Addendum to the Berths 302-306 APL Container Terminal Project Final Environmental Impact Report

APP No. 081203-131

October 17, 2016

Figure 1 – Approved Expansion Project at Full Buildout as Assessed in Final EIR

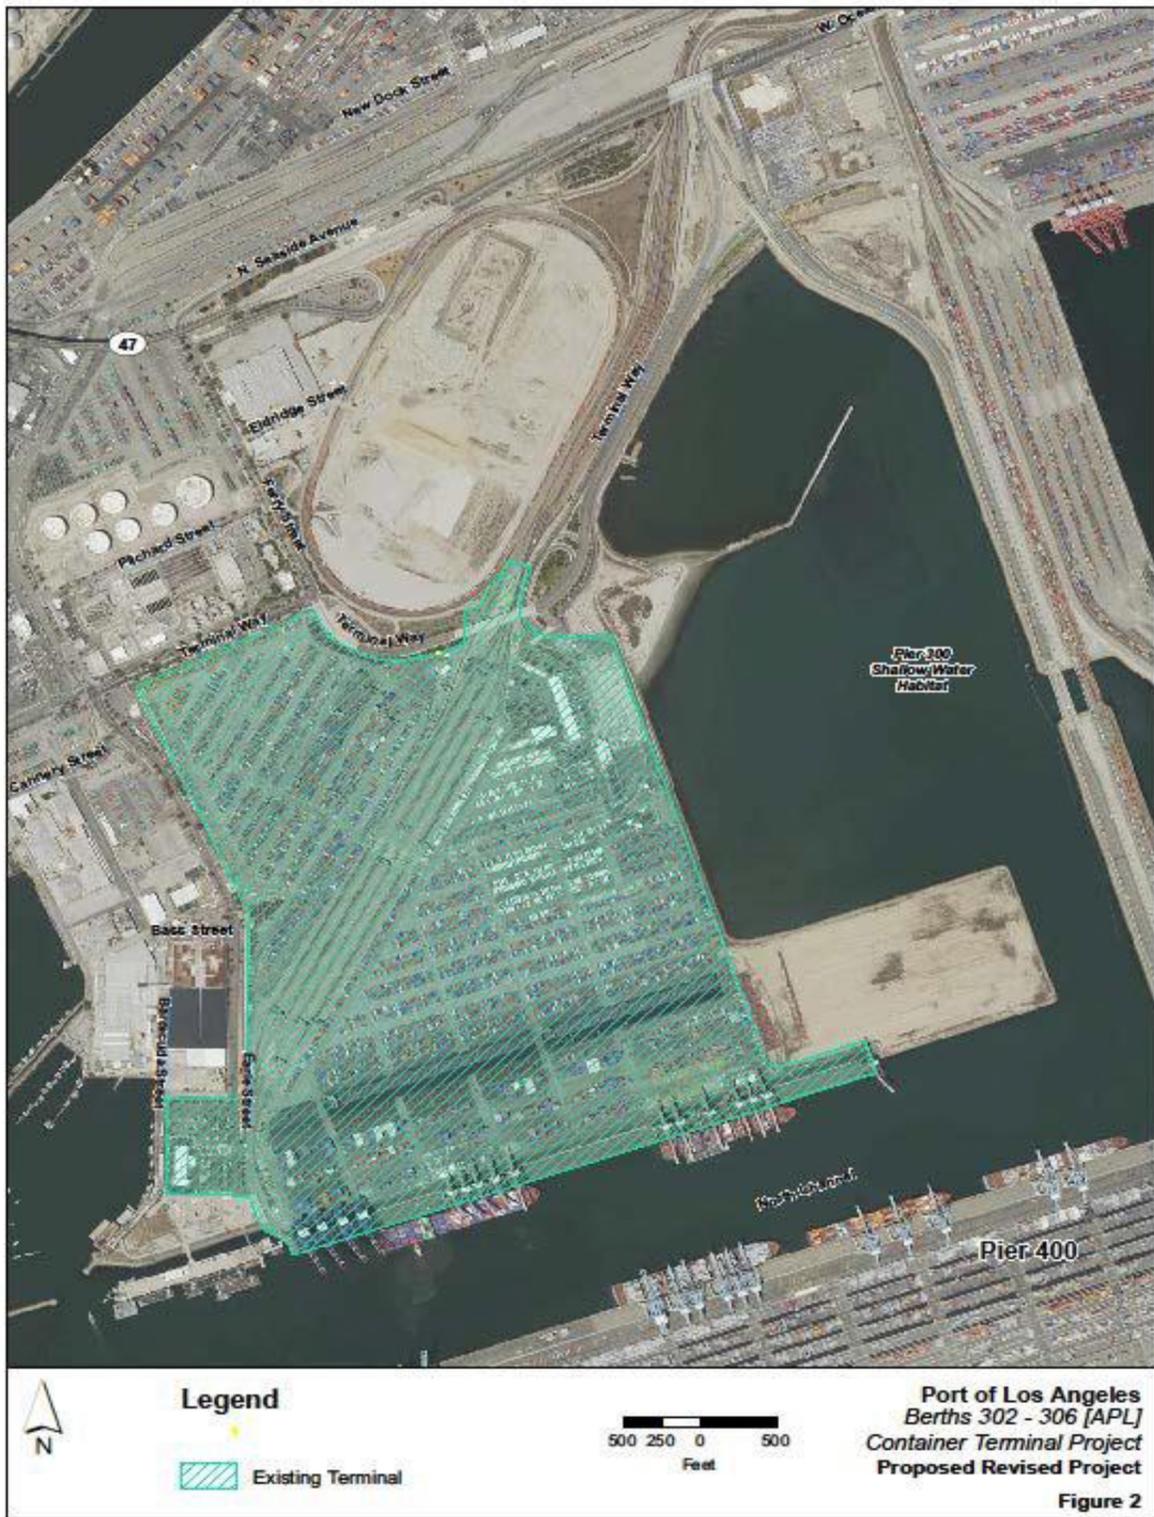
Figures 1 and 2 below highlight the Approved Expansion Project and the Proposed Revised Project.

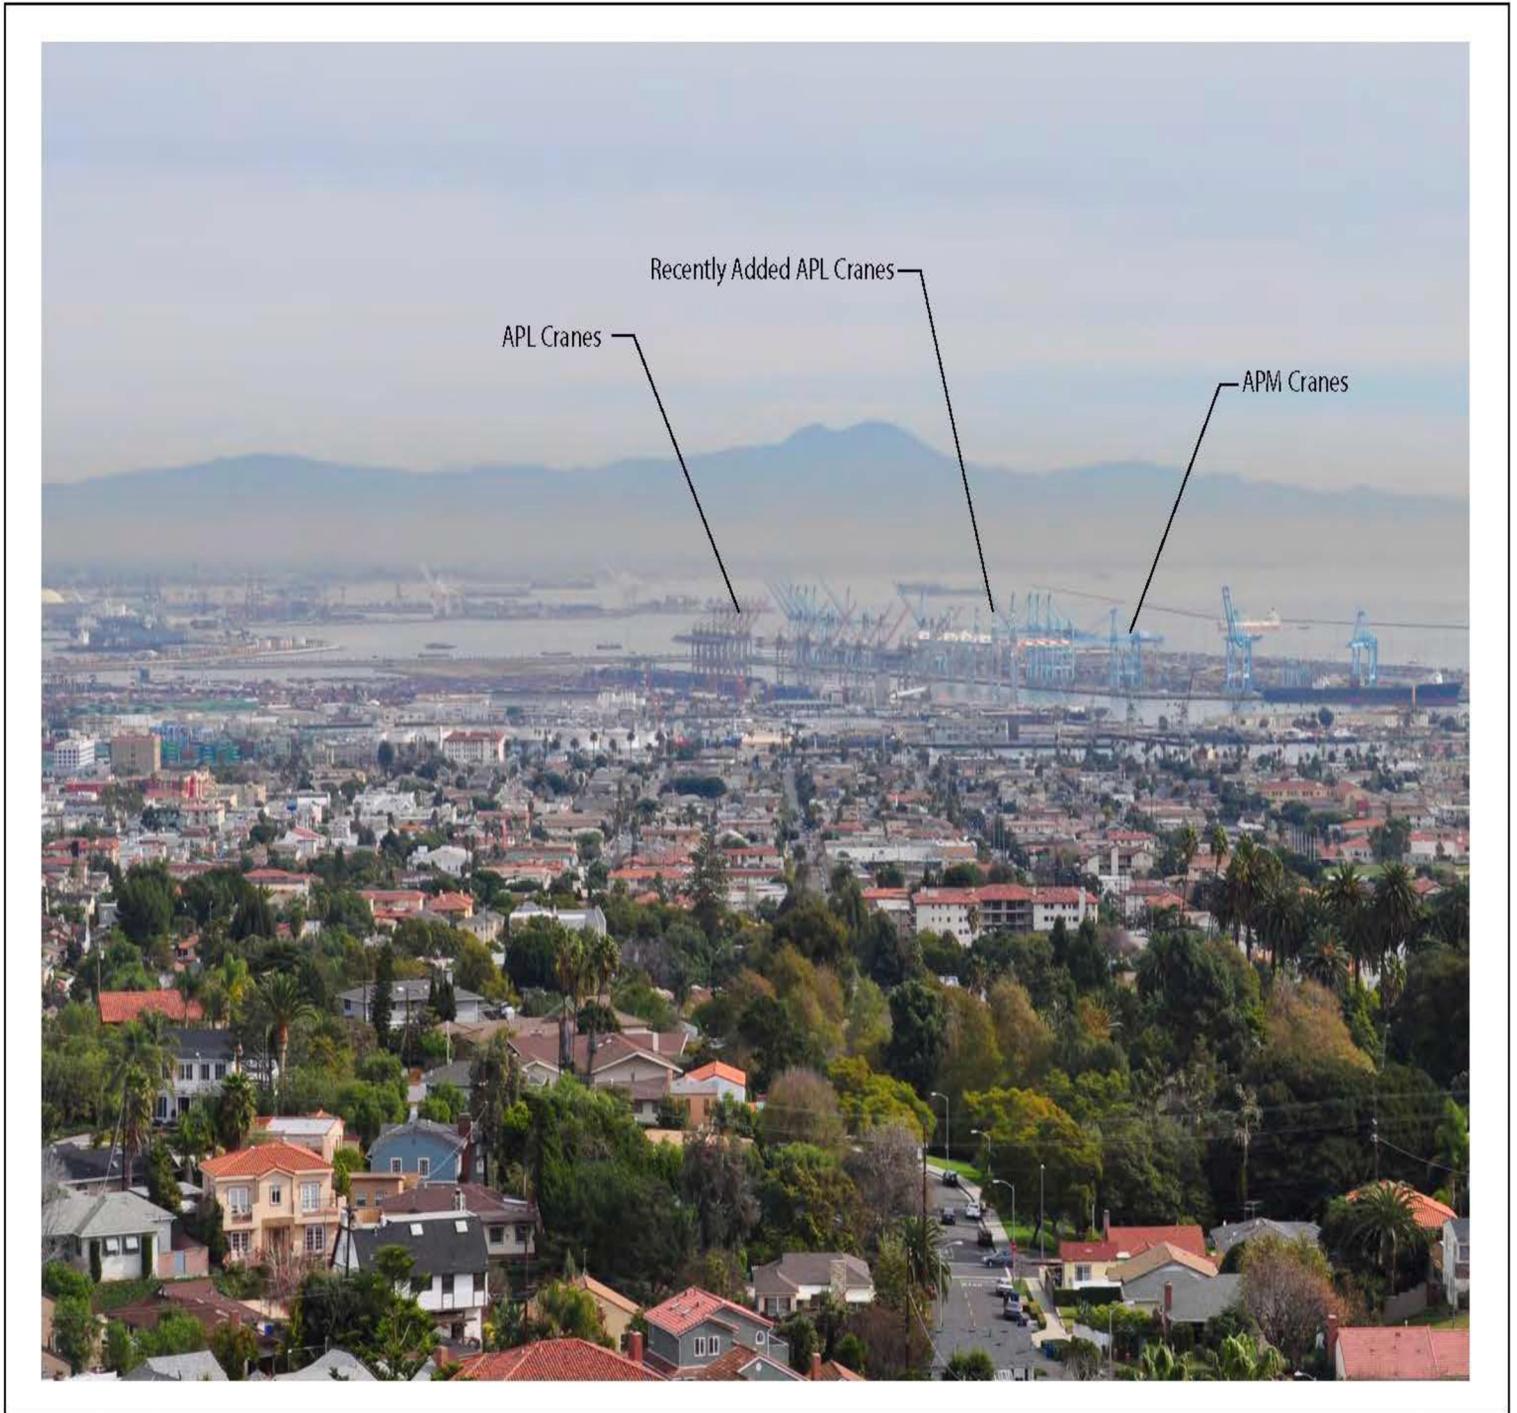
As described in Table 1, the Proposed Revised Project would have a maximum of 16 cranes located on Berths 302-305, the same number as approved for Berths 302-305 under the Approved Expansion Project. (The Approved Expansion Project also permitted eight cranes on Berth 306 which is not part of the Proposed Revised Project). For this reason, crane density impacts from the Proposed Revised Project would be the same or less than the Proposed Expansion Project and would therefore be less than significant for the same reasons as determined in the Final EIR (Ibid). Crane heights were also evaluated in the Final EIR. As described in Table 1, crane heights for the Proposed Revised Project would consist of 4 cranes equal in height to the 12 original Pier 300 facility cranes that were analyzed in the Final EIR (280' in stowed position), 4 cranes equal in height to the 12 new cranes analyzed in the Final EIR (340' in stowed position), and 8 new cranes (375' in stowed position) that would replace 8 of the 12 original cranes.

To ensure that the 8 replacement cranes would not create an adverse aesthetics impact not previously identified in the Final EIR, a representative viewpoint from the Final EIR was revisited for a comparison
